**ADDENDUM #2**

REQUEST FOR QUOTATIONS (RFQ) NO.: 1220-040-2019-098  
TITLE: SUPPLY, DELIVERY AND INSTALLATION OF HVAC  
REPLACEMENT – SURREY ARTS CENTRE  
ADDENDUM ISSUE DATE: December 5, 2019  
CLOSING DATE: prefer to receive Quotations on or before:  
December 12, 2019

**2. AHU-2 REVISION**

M-2

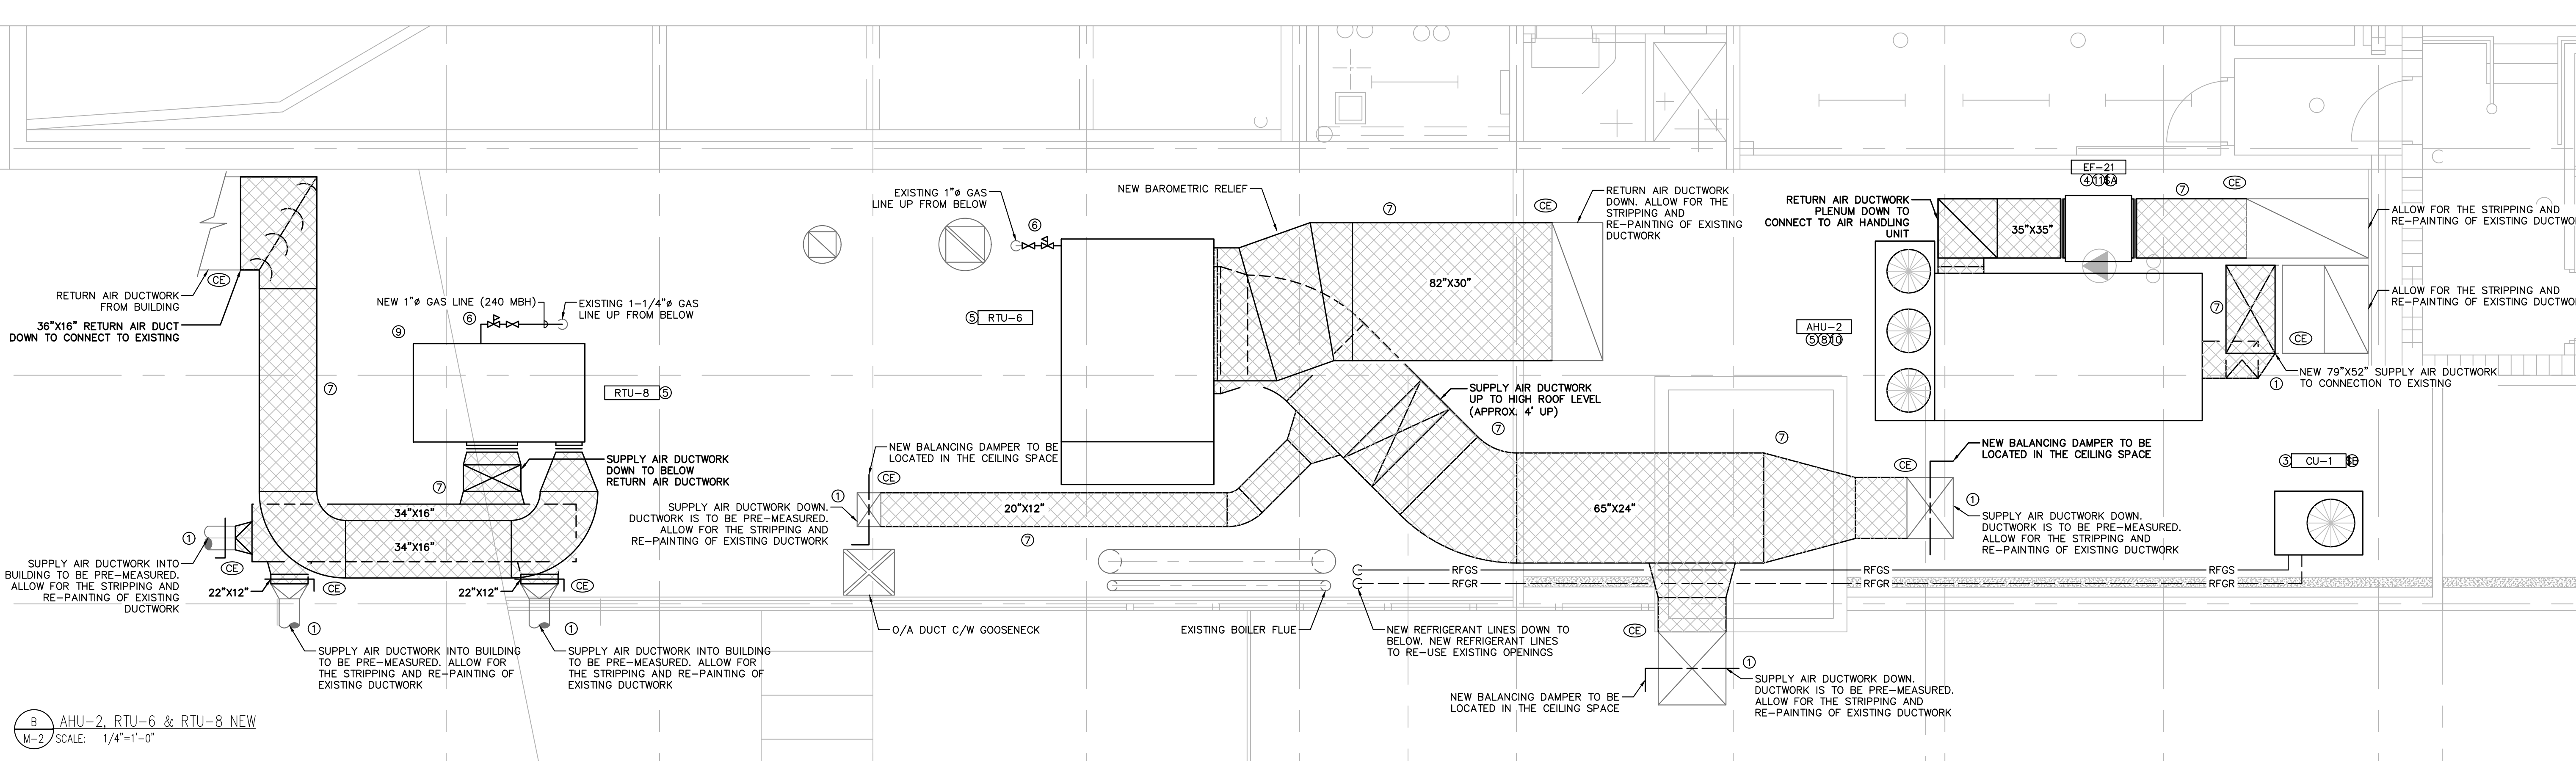
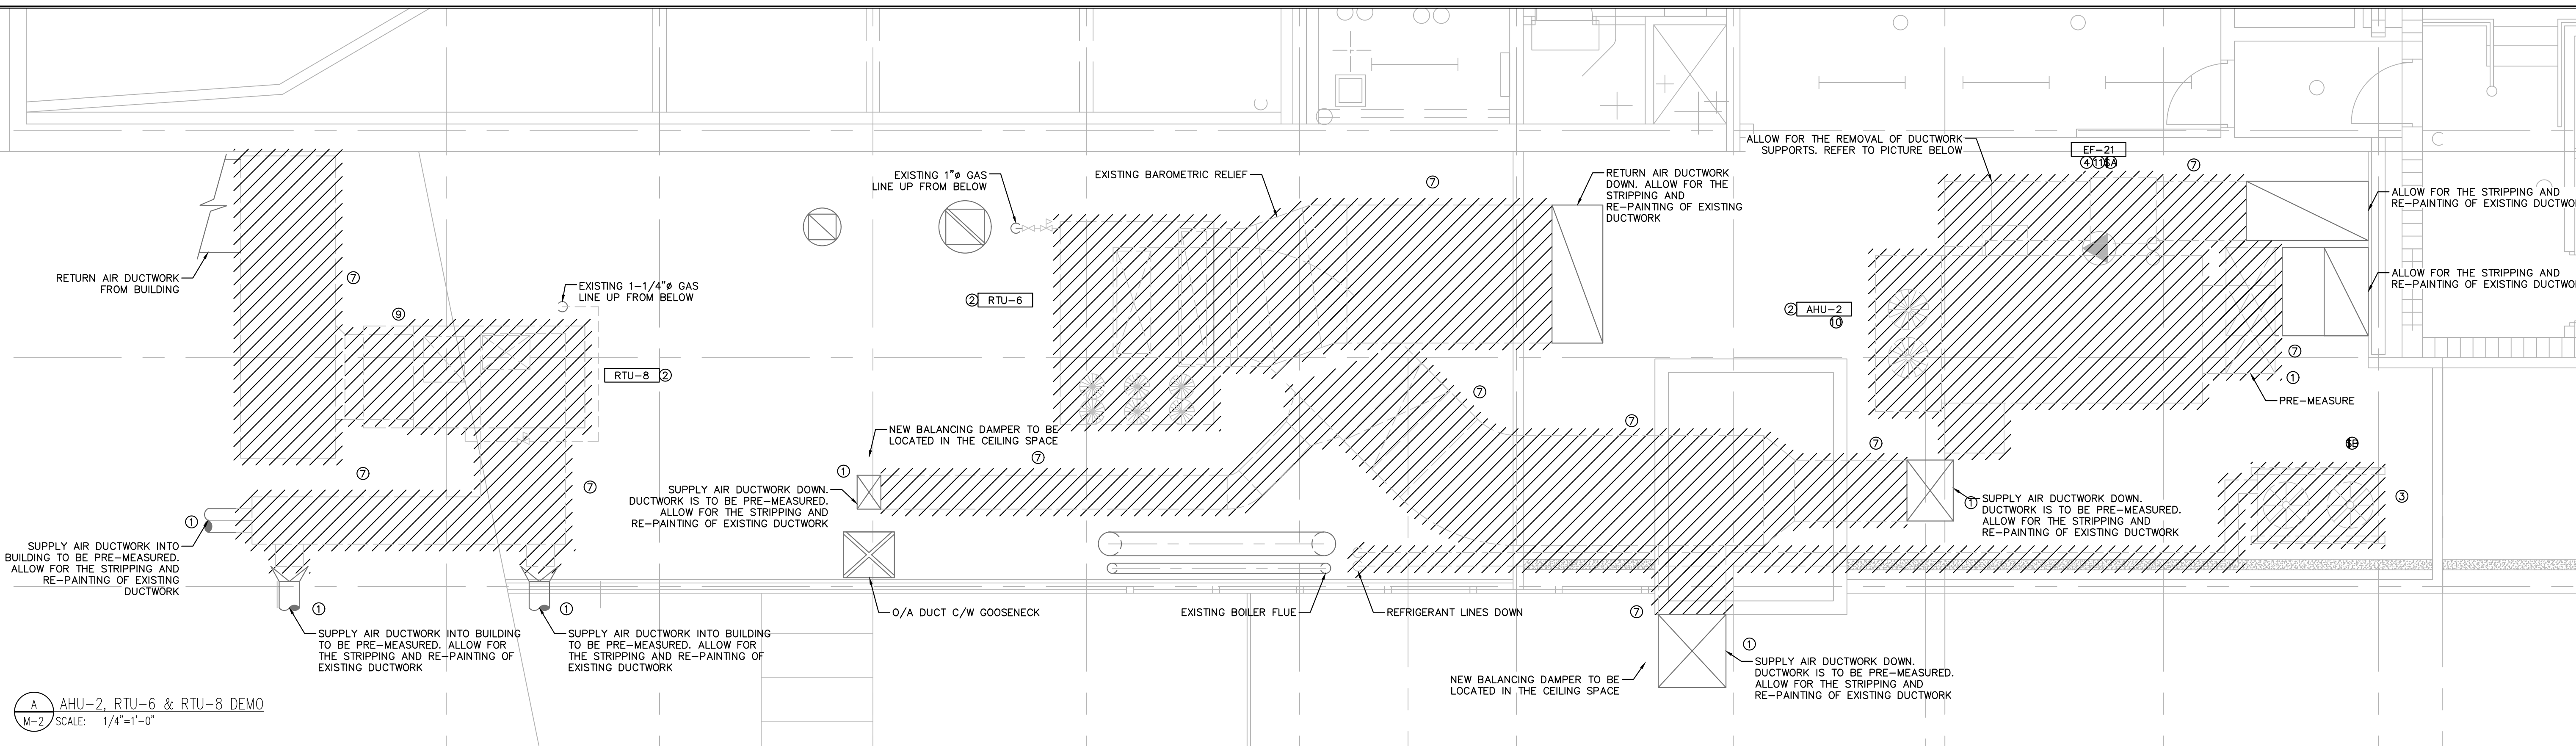
- 2.1 AHU-2 model is to be revised to FEW-224-COR. AHU-2 is to be provided complete with:
  - 16 ga. satin coated galvanized sheet metal casing c/w 2", 3lb.ft<sup>3</sup> semi ridged insulation
  - 16 ga.. satin coated galvanized sheet metal floor
  - Air side access doors – hinged c/w lever lock handles
  - Service doors (electrical & compressors) – hinged c/w lever lock handles
  - Supply motor and fan to have seismic spring vibration isolation c/w extended grease lines – both to exterior casing and pillow block bearings
  - Drives to have a 1.0 service factor
  - Alternate tube circuited DX coil c/w hot gas bypass on lead compressor and stainless steel drain pan

- Piping vestibule for hot water coil
- Filter gauge 0-2 in-wc.
